## **2.5 Geology, Seismology, and Geotechnical Engineering**

In Section 2.5, "Geology, Seismology, and Geotechnical Engineering," of the SSAR, SERI provided a detailed description of the geological, seismological, and geotechnical engineering properties of the ESP site. In this SER, Section 2.5.1, "Basic Data," describes basic geological and seismological data, especially the data published since 1986 for the area within a 200-mile radius of the ESP site, and presents updated seismic sources. Section 2.5.2, "Vibratory Ground Motion," evaluates the vibratory ground motion for the ESP site and analyzes the safe-shutdown earthquake (SSE) ground motion. Section 2.5.3, "Surface Faulting," describes the potential for surface faulting at or near the surface of the ESP site. Section 2.5.4, "Stability of Subsurface Materials and Foundations," presents the results of site geotechnical investigations and discusses the stability of subsurface materials and foundations. Section 2.5.5, "Stability of Slopes," defers the analyses for slope stability at the site and dam performance, respectively, to the COL stage. Finally, Section 2.5.6, "Embankments and Dams," briefly states that no embankments e

Figure 2.5.4-5 (Updated final version of SSAR Figure 2.5-87)  
 Shear Modulus Reduction Curves For Loess

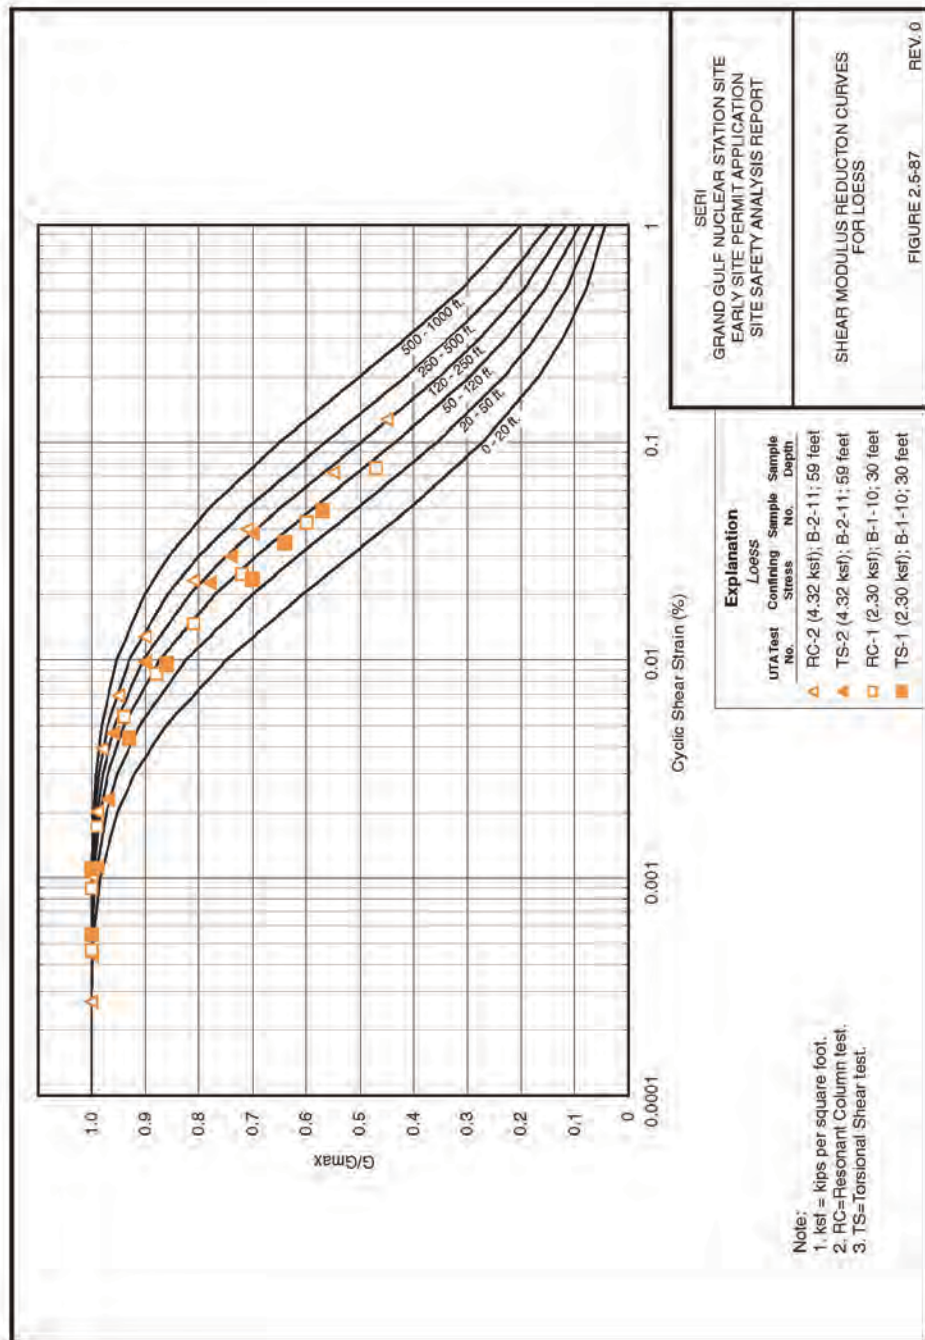
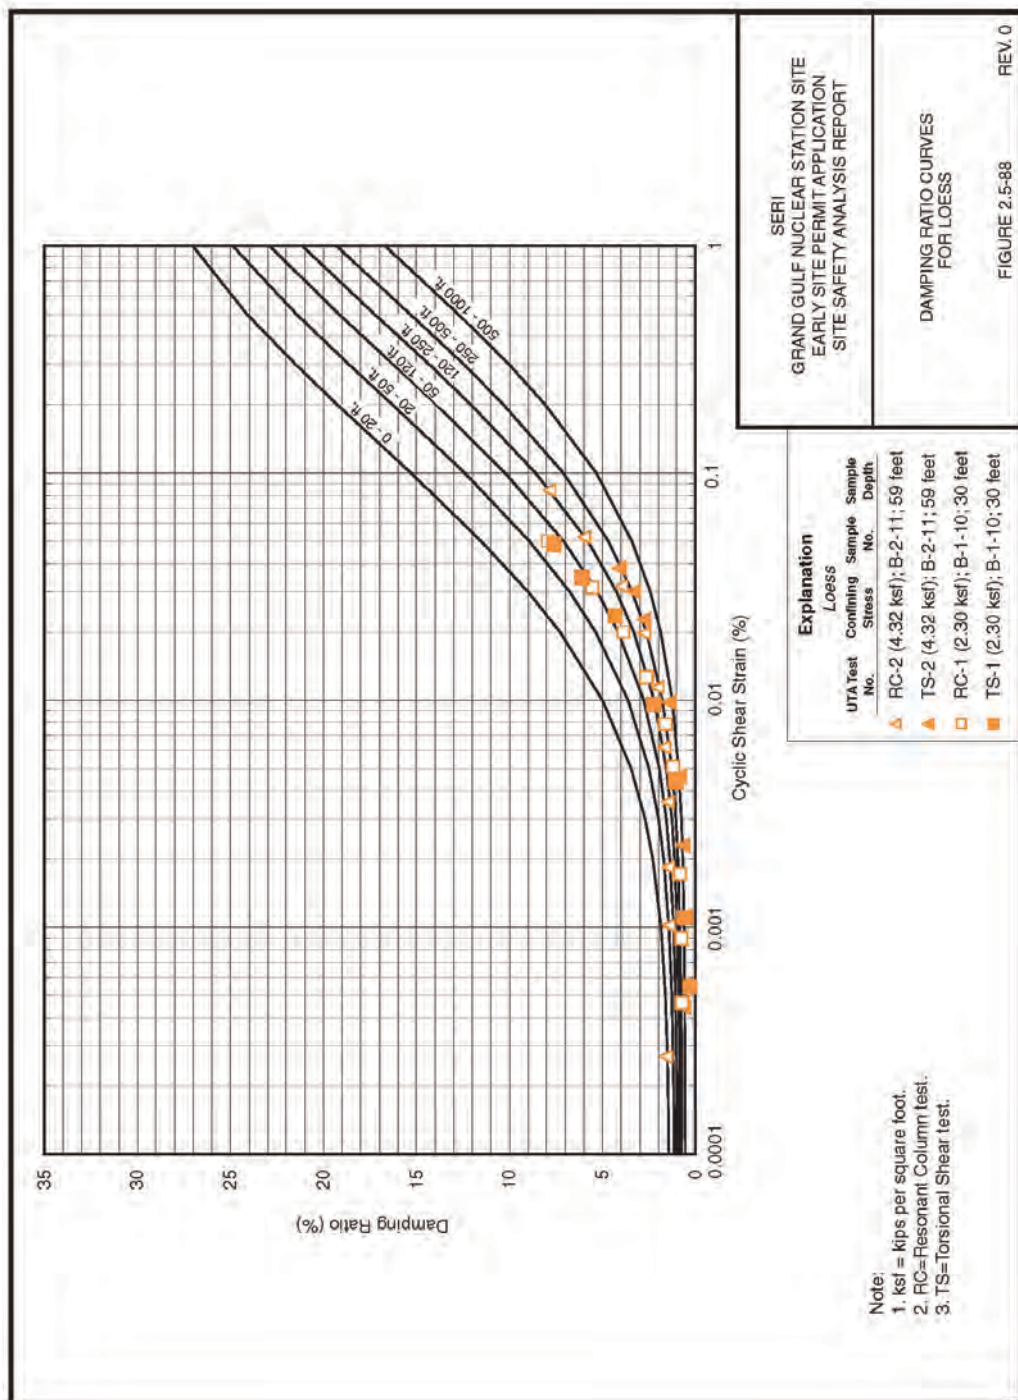
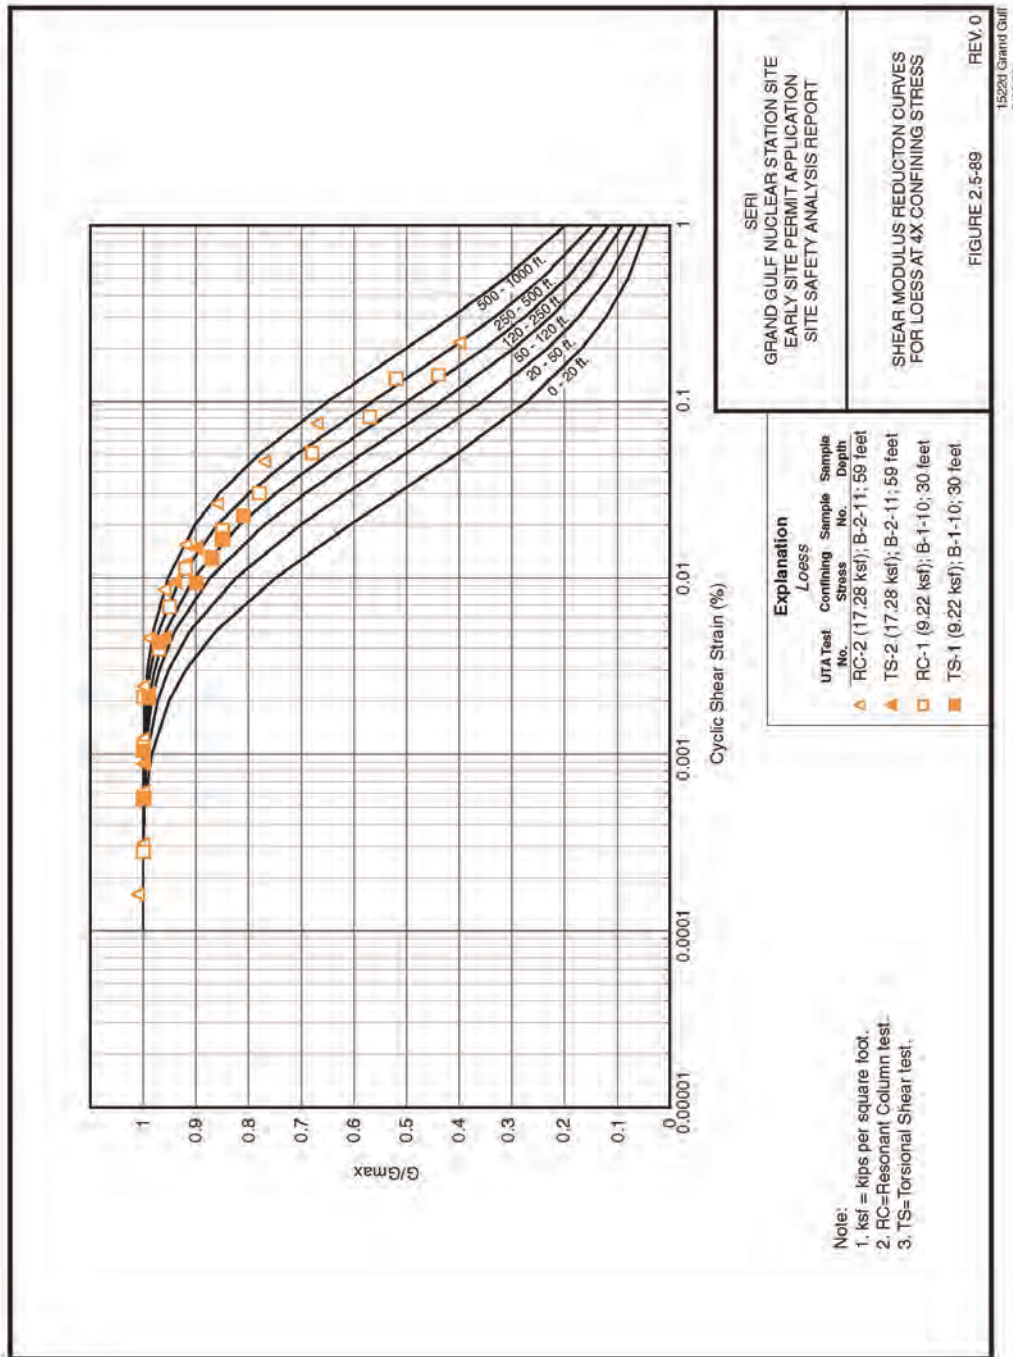
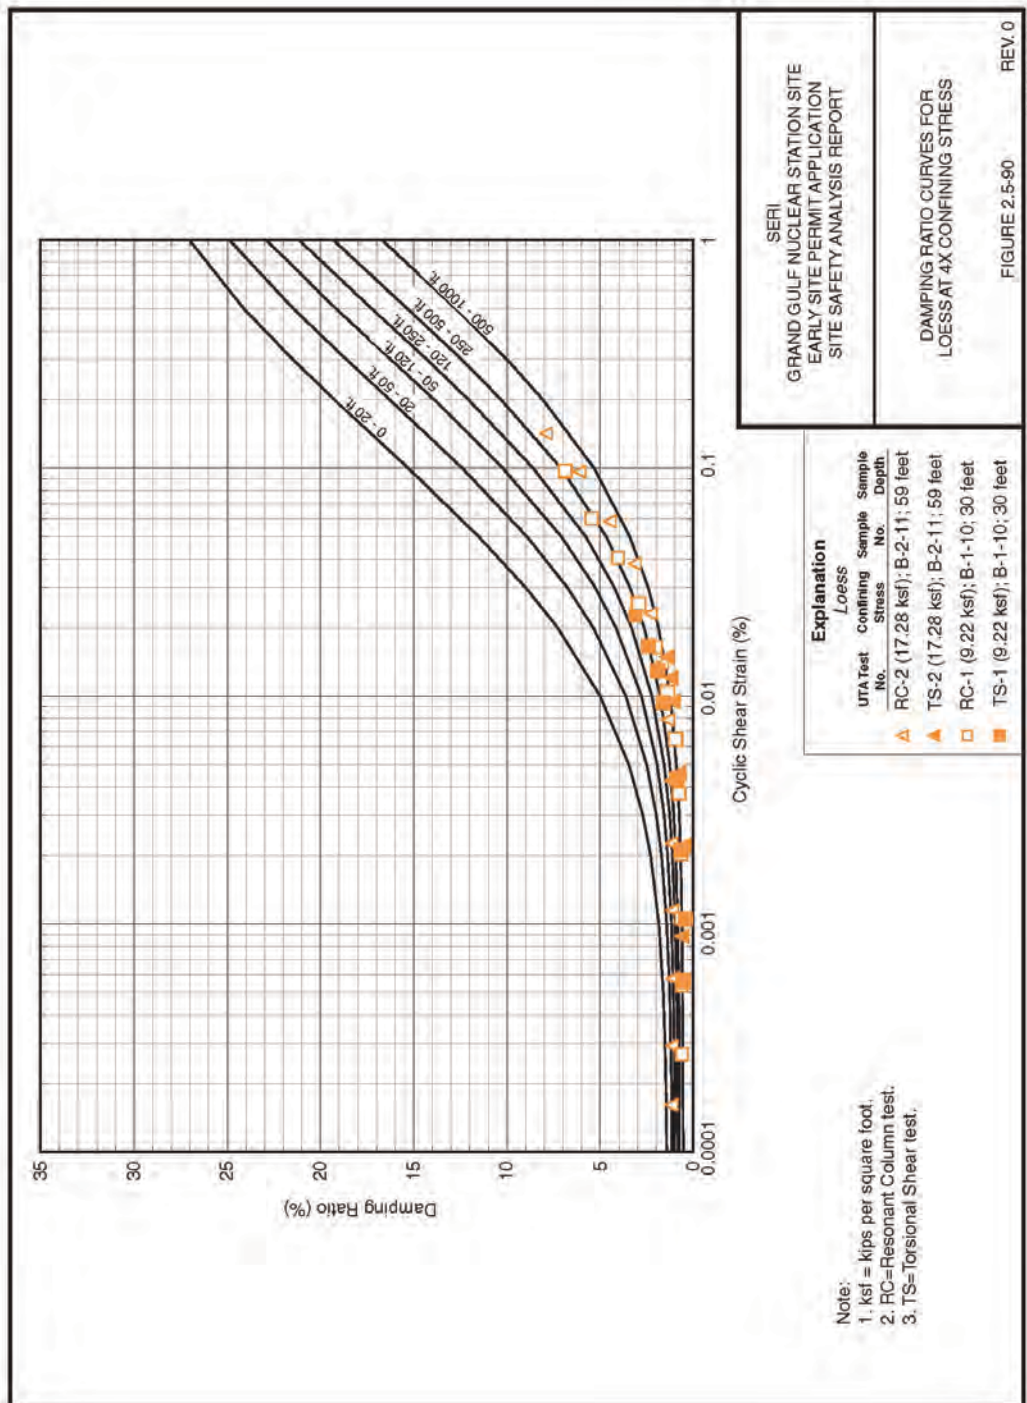
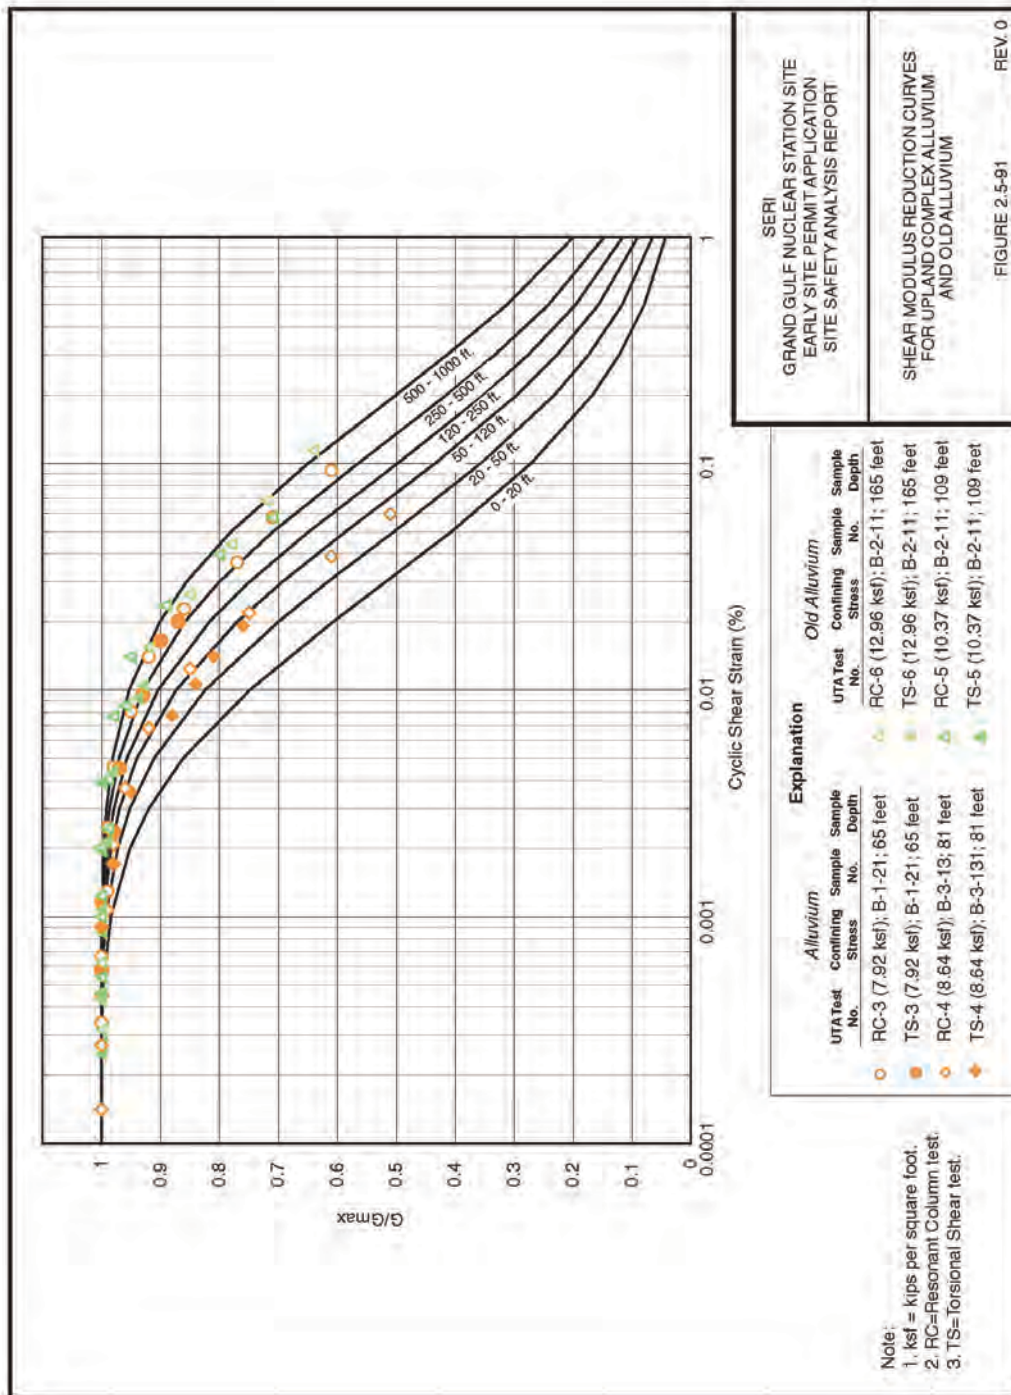
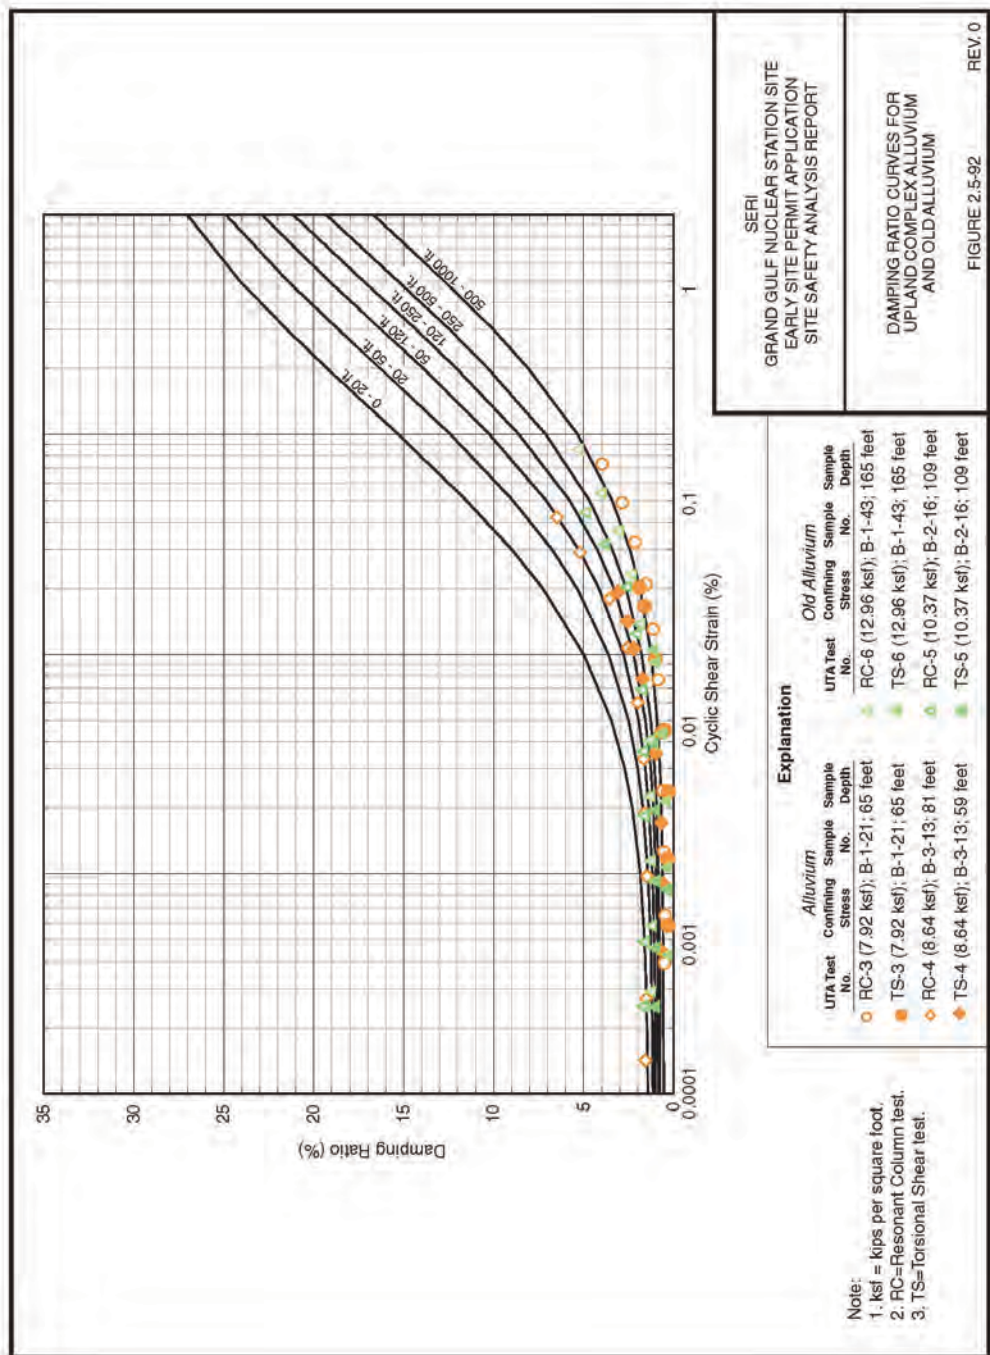
In RAI 2.5.4-7, the staff asked the applicant to provide its rationale for not incorporating these effects in the site response calculations and to evaluate the potential impact of these modifications on the computed surface UHRS. In its response, the applicant referred to its response to RAI 2.5.4-6 and stated that the analysis and selection of the appropriate EPRI-TR curves for shear modulus reduction and hysteretic damping fully account for the effects of possible disturbance to the test specimens resulting from stress release during sampling, as well as possible movements during testing. The applicant considered the effects of sample relaxation by examining the results from testing soils at both the estimated in situ confining stress and 4 times the estimated in situ confining stress. The applicant plotted these two data sets together on the EPRI-TR base curves as shown in Figures 2.5.4-5 through 2.5.4-12, which replicate SSAR Figures 2.5.4-87 to 2.5.4-94. The two data sets were weighted to select the most representative EPRI-TR curve.

In its response, the applicant further stated that the shear modulus reduction and damping curves adopted for use in the site response analysis represent the best fit to the dynamic soil test results that account for the effects of soil disturbance and overconsolidation. The applicant also considered the uncertainty and variability in these values in the site response modeling by developing randomizing curves about the selected base case EPRI-TR curves using an assumed lognormal distribution. The applicant further discussed the randomization process in its response to RAI 2.5.4-8 (for shear wave velocity input). The applicant considered that the EPRI-TR curves selected for the base case for site response analysis are appropriate for the site soil conditions and account for both sample disturbance and overconsolidation. Therefore, incorporation of these issues would not impact the computed surface UHRS.
